Plate 1: Existing Zoning & Location Map  
 OP 21-12-8 & ZN 8-21-14 - 1991976 Ontario Inc. - 1185 & 1201 Devonshire Avenue, Woodstock

Plate 3: Applicant's Concept Plan  
 OP 21-12-8 & ZN 8-21-14 - 1991976 Ontario Inc. - 1185 & 1201 Devonshire Avenue, Woodstock

AGENCY COMMENTS – OP 21-12-8 – 1991976 Ontario Inc.

AMENDMENT NUMBER 272  
TO THE COUNTY OF OXFORD OFFICIAL PLAN

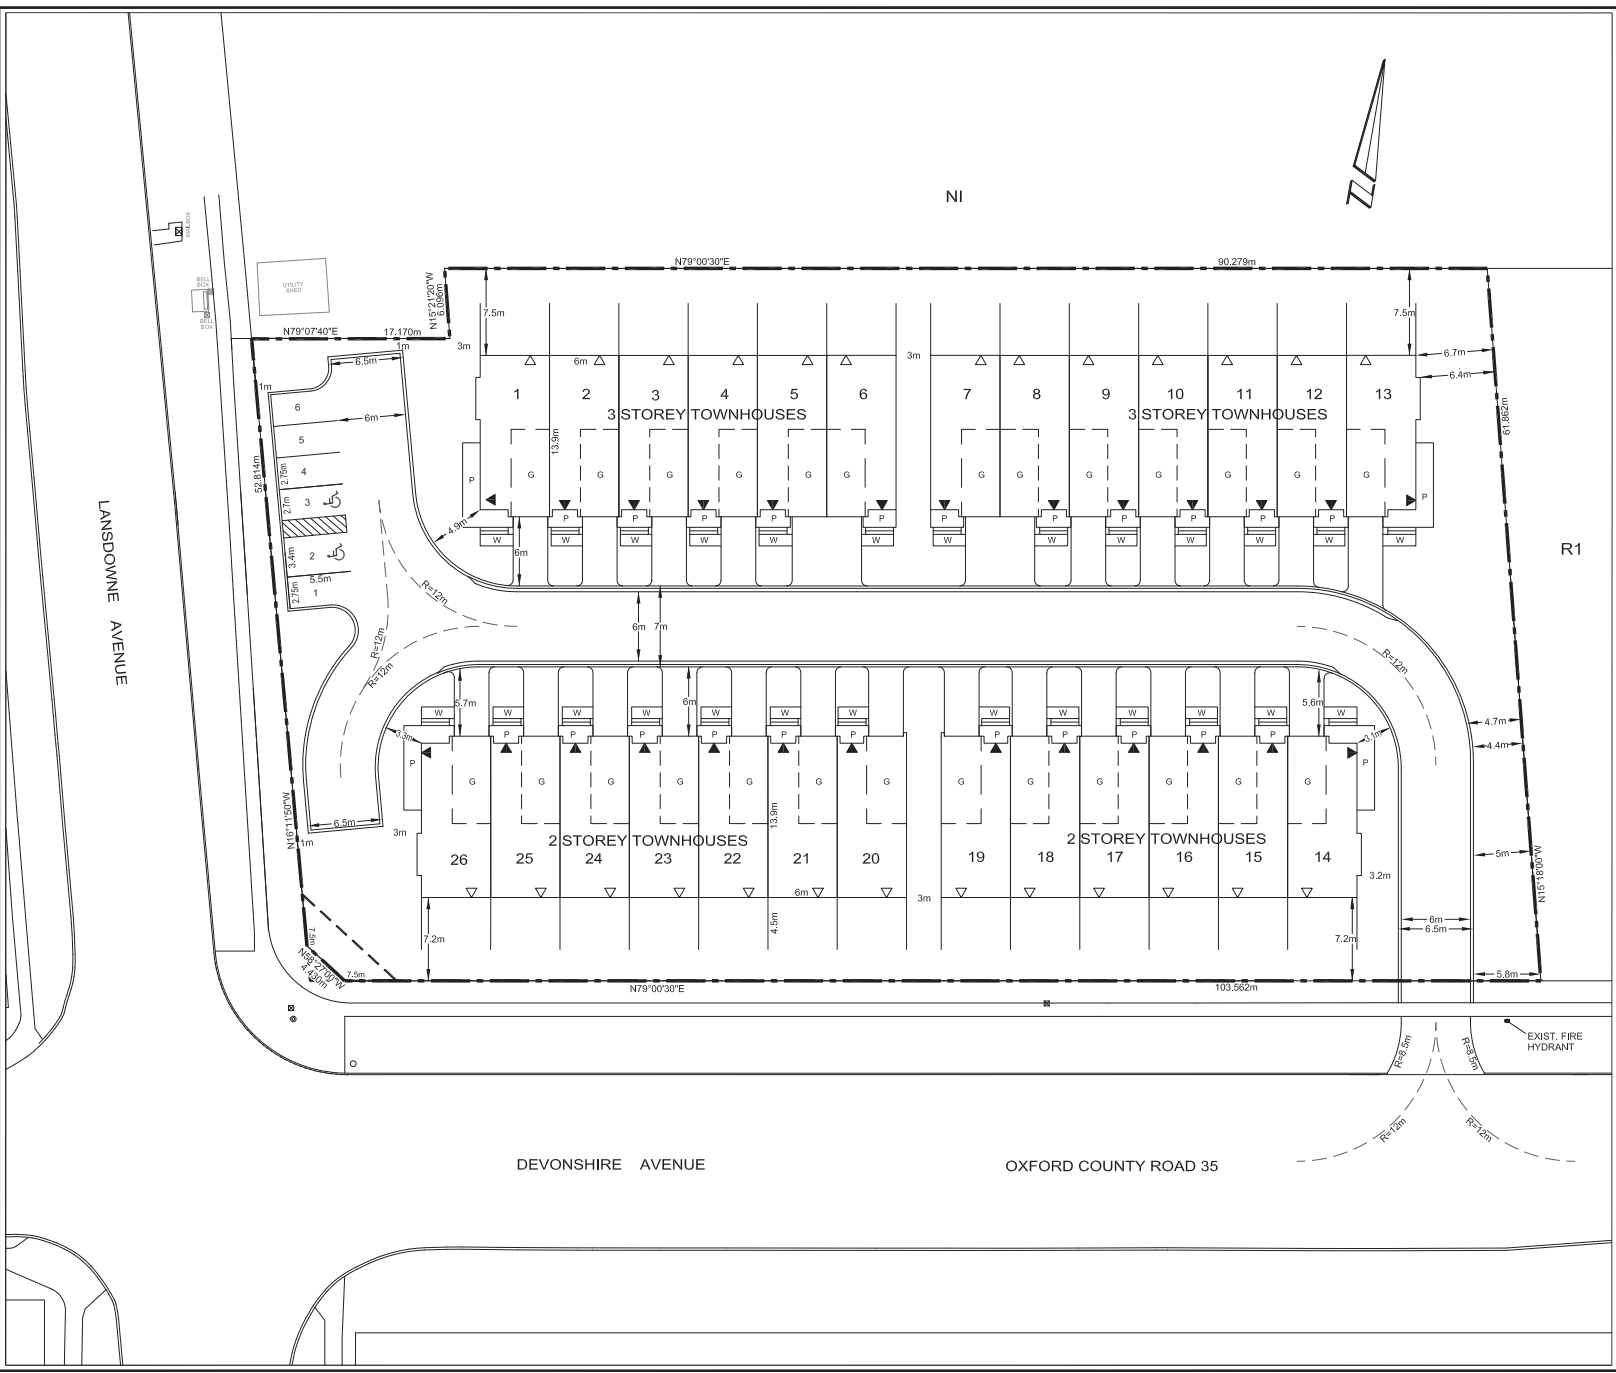
- The proposal is for 26 horizontally attached townhouse units.
- Relief is required to reduce the minimum required lot area. Area provided as per the applicant's plan is 6,494.28 m<sup>2</sup> (69,906.1 ft<sup>2</sup>). The required area is 26 units x 280 m<sup>2</sup> (3,013.9 ft<sup>2</sup>) = 7,280 m<sup>2</sup> (78,363.8 ft<sup>2</sup>). The provided area is 249 m<sup>2</sup> (2,680 ft<sup>2</sup>).

- Relief is required to increase the maximum lot coverage from 35% to 35.42%. We suggest rounding to 36%.
- Relief is required to reduce the minimum rear yard depth from 7.5 m (24.6 ft) to 6.4 m (20.9 ft).

- Relief is required to reduce the minimum parking area setback from street line from 1.5 m (4.9 ft) to 1 m (3.2 ft) and to permit parking in the front yard.

- The minimum required width of the driveway is 6.7 m (21.9 ft). This will be required through the site plan approval process.
- The applicant should be advised that the proposed development will be subject to site plan approval.

- The applicant adjusted the proposed concept plan to retain the hedge along the eastern property line.
- A thorough review of the Landscape Plan and Tree Compensation Plan will take place through the site plan approval process.

The City of Woodstock Fire Department indicated that they have concerns regarding the distance from the existing municipal fire hydrant to the furthest principle entrance. It should not exceed 90 m (295.2 ft) for the unobstructed path of travel. The applicant will be required to provide further information, which can be addressed through site plan approval.

- **Parking:** With allowance for only 1 car per driveway and no parking on Devonshire or Landsdowne where will overflow parking go?
- **Noise levels:** the proposed driveway is directly beside my home. This is bound to create a much higher noise level than presently exists.
- **Light pollution:** Lighting will directly affect my home and property both from street lights and traffic on the proposed roadway which will

- Existing trees on property line. I was assured by the owner of the property that the existing trees will remain. There is a significant grade change between the two properties. In adjusting the grade, will it kill the trees? Will they in fact be removed as all the other beautiful mature trees that were there have been?

- Driveway Location: The proposed driveway is directly beside mine. Anyone who misses the driveway into the townhouse complex will end up turning around in my driveway, and since it is a U drive I suspect many will just drive around.

1. Will there be a fence erected and if so, how high will it be and what will it be made of? If a fence is erected, how will it affect the existing trees on the property line.
2. Are the units going to be condominiums or rental units?

1. Reduce of the number of units allow for double driveway parking. I would also request the fence be erected on the west side of the trees so they will not be damaged by excess snow removal and will remain in tact.

2. No windows on the sides of the units facing my property.

3. Reduce the 3 storey units to 2 story units.

4. Privacy fences on the decks facing my property.
